DATE: <b>12/19/2017</b>	JOB NO. <b>1808</b>
ATTENTION: <b>Planning Department</b>	
RE: <b>Amended Site Plan Approval</b>	
<b>46 - 64 Maplewood Avenue</b>

## 46-64 MAPLEWOOD AVENUE

**RE: Application for Site Plan Review for 46 – 64 Maplewood Avenue, Portsmouth**

On behalf of 30 Maplewood, LLC, we hereby submit revised plans for the 46 - 64 Maplewood Avenue project for TAC approval. The plan set has been revised to address the comments from the October 31 Technical Advisory Committee meeting. The plans have been revised to reflect the following comments, with response in **bold** text:

**SITE PLAN**  
**BASEMENT LEVEL** **C4**

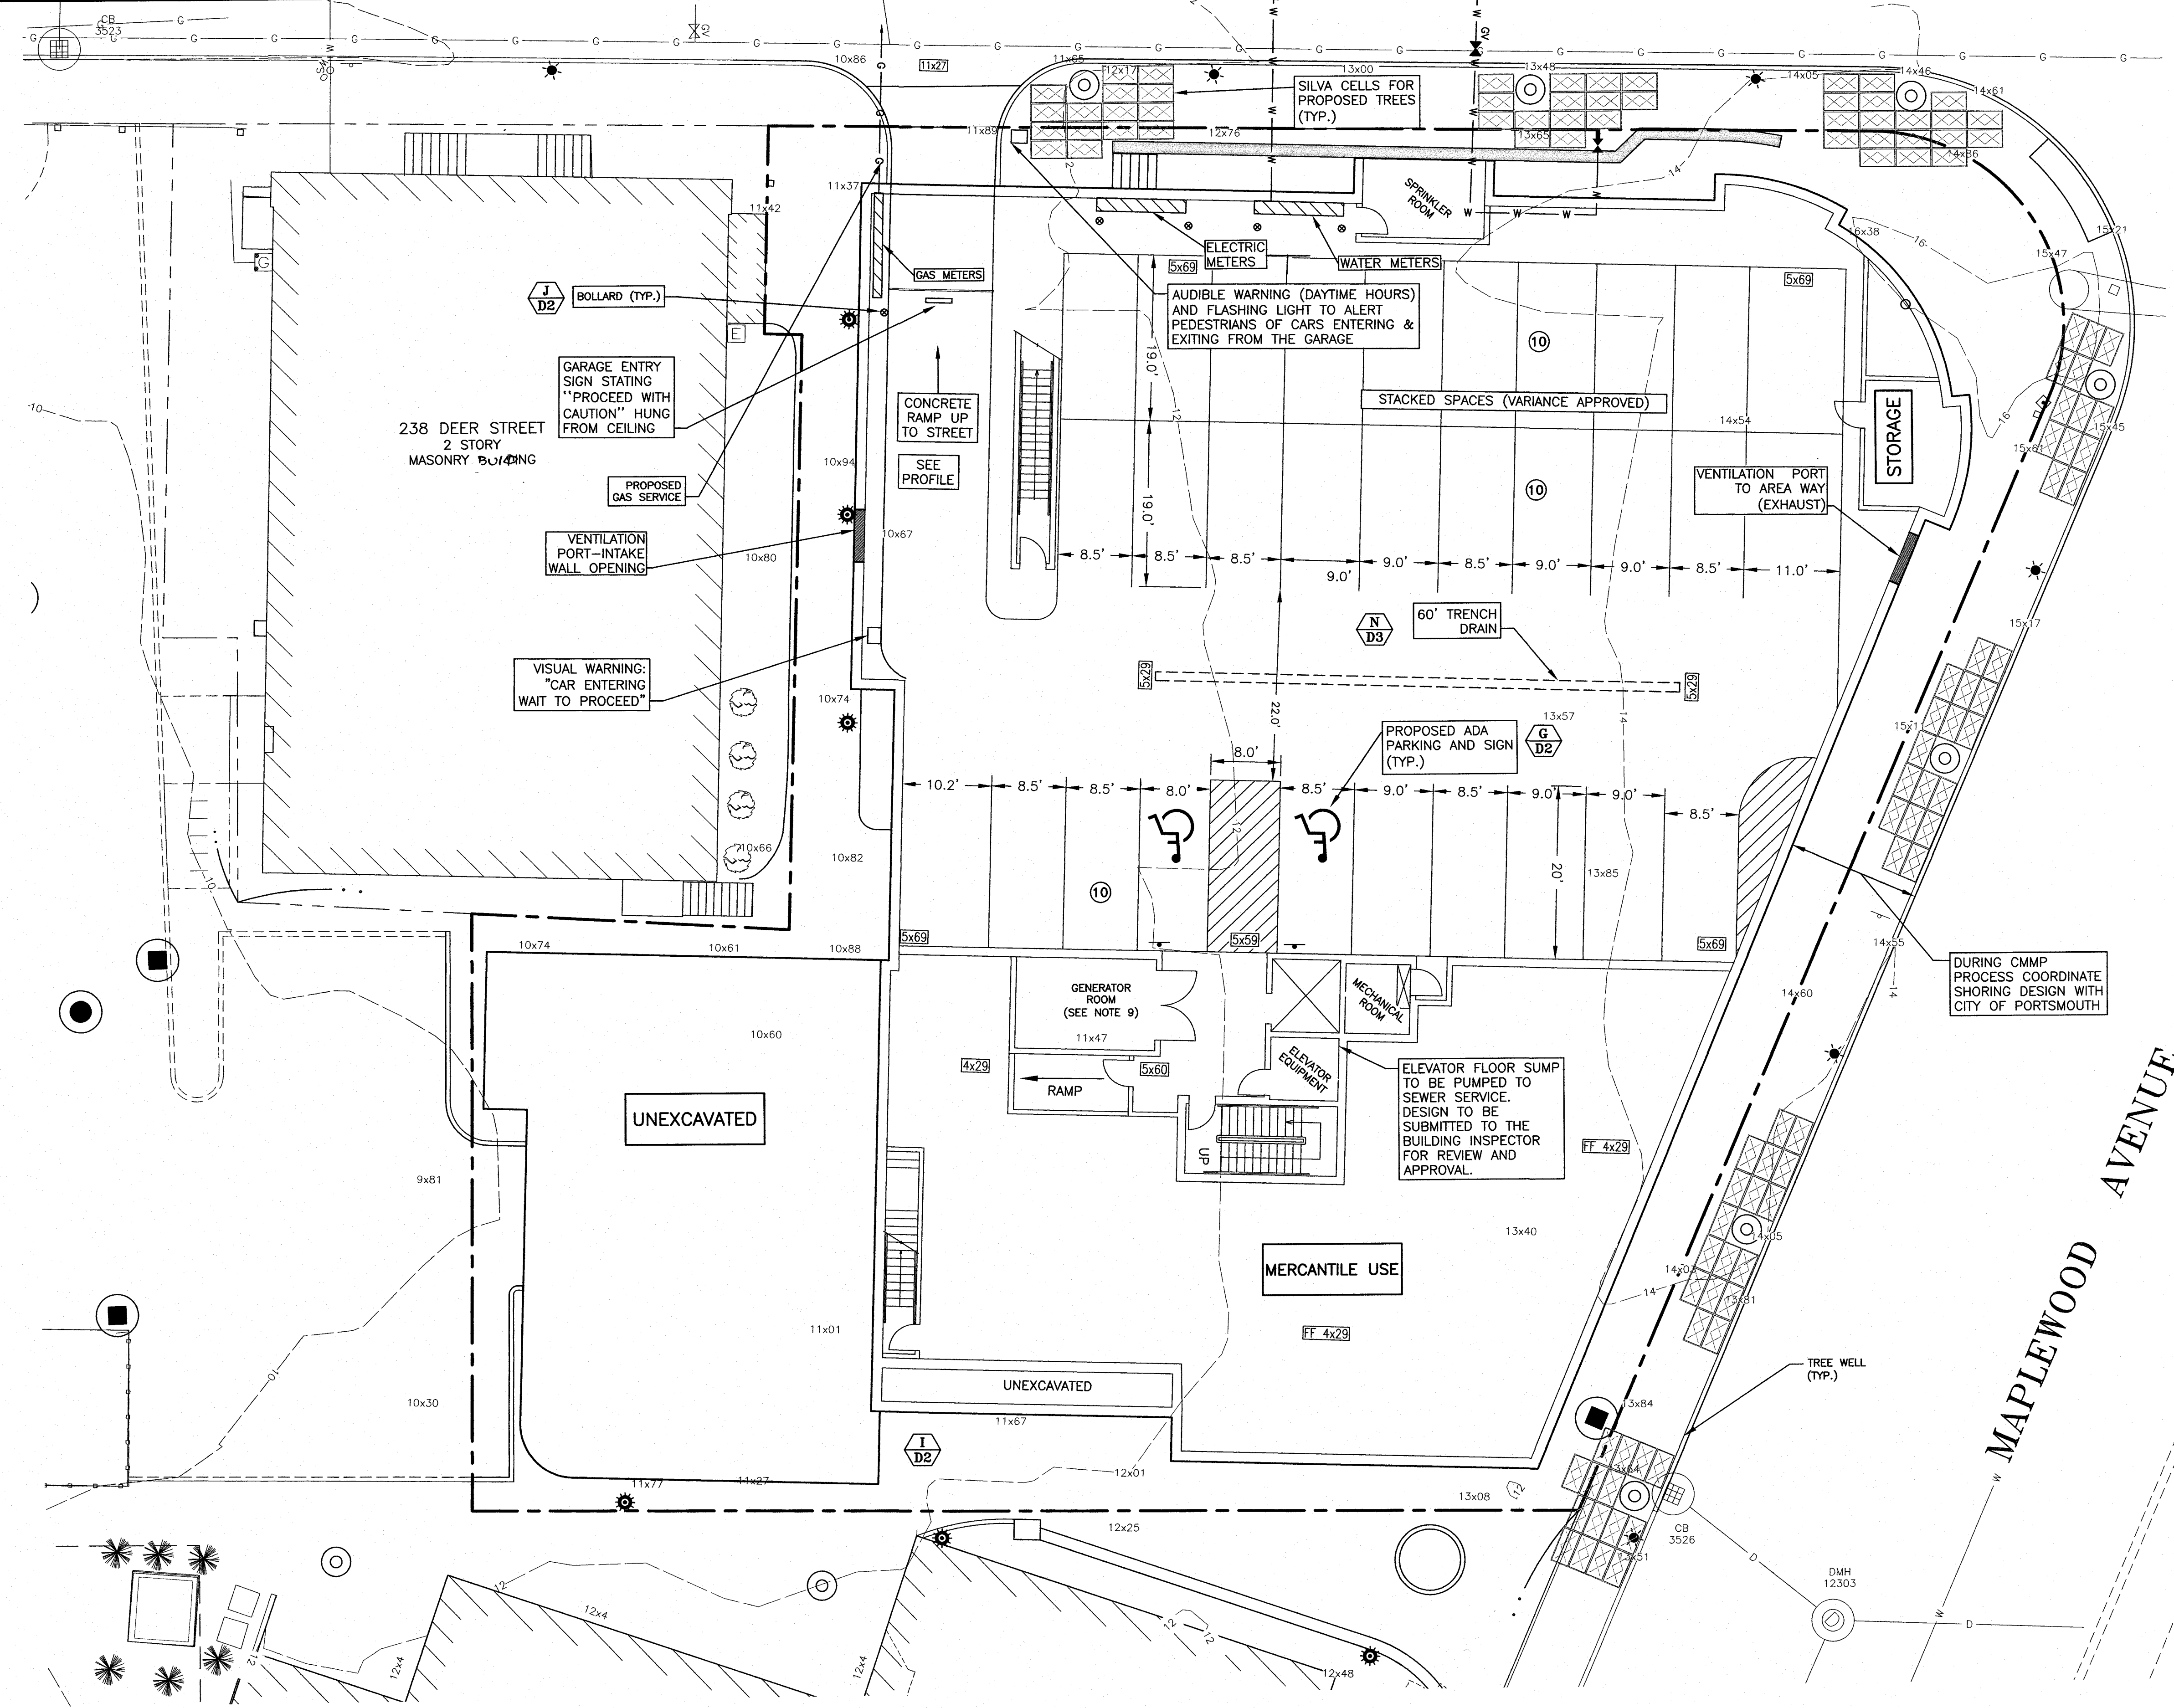
- Please verify that there is 7' of clear space between the trees and the wall of the building. **This was verified.**
- The handicapped access aisle in the basement should be 8 feet wide if it is to serve a van space. **Comment addressed; See Sheet C4.**

- The previous TAC comments requested that the generator for the garage be shown on the site plan. **The generator has been added to Sheet C4.**

- Please respond to previous TAC comments regarding cross ventilation requirements for the garage and 2nd egress requirements. **Comment addressed; See Sheet C4, we added an areaway exit and intake locations.**

**UTILITY PLAN** **C5**

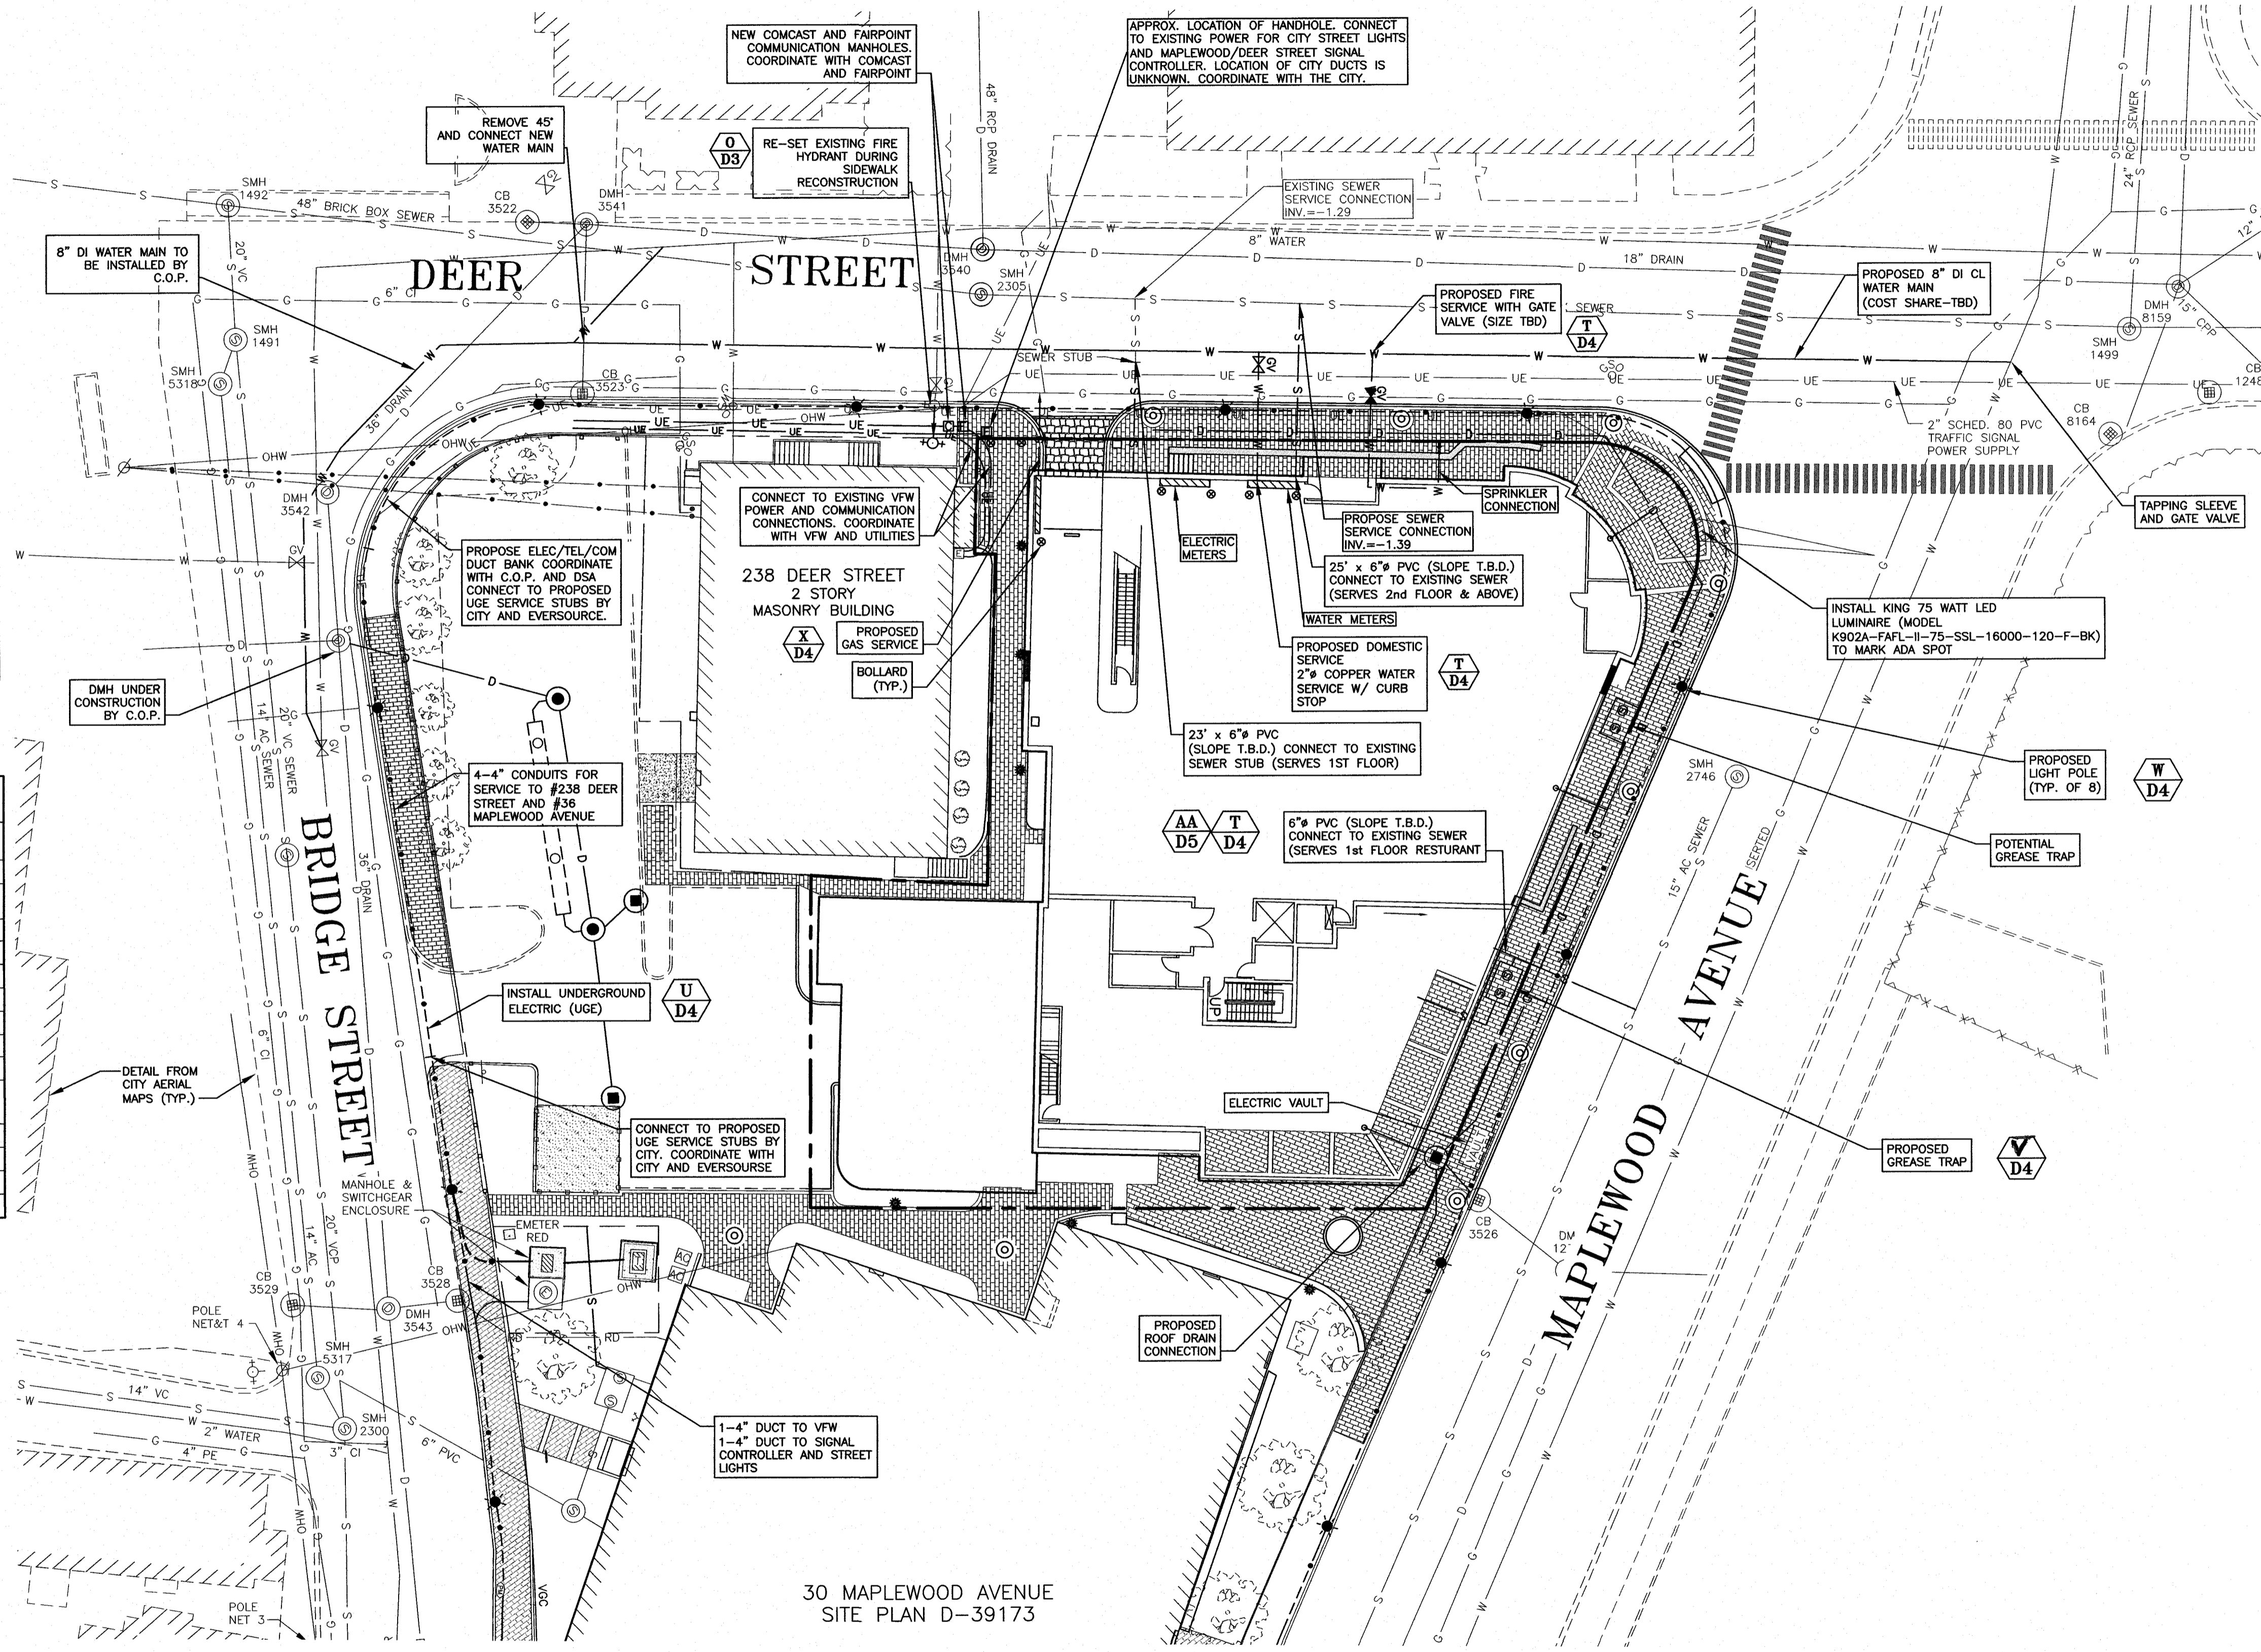
- TAC will be recommending that the applicant contribute to the cost of the replacement of the water main on Deer Street and shall show the new services tying into this new line. **This has been shown on the Utility plan.**

- Please respond to previous TAC comments regarding sprinklering for any portions of the building that have at least a 7' ceiling height, confirm sprinkler connection location. **Comment addressed; See Sheet C5.**
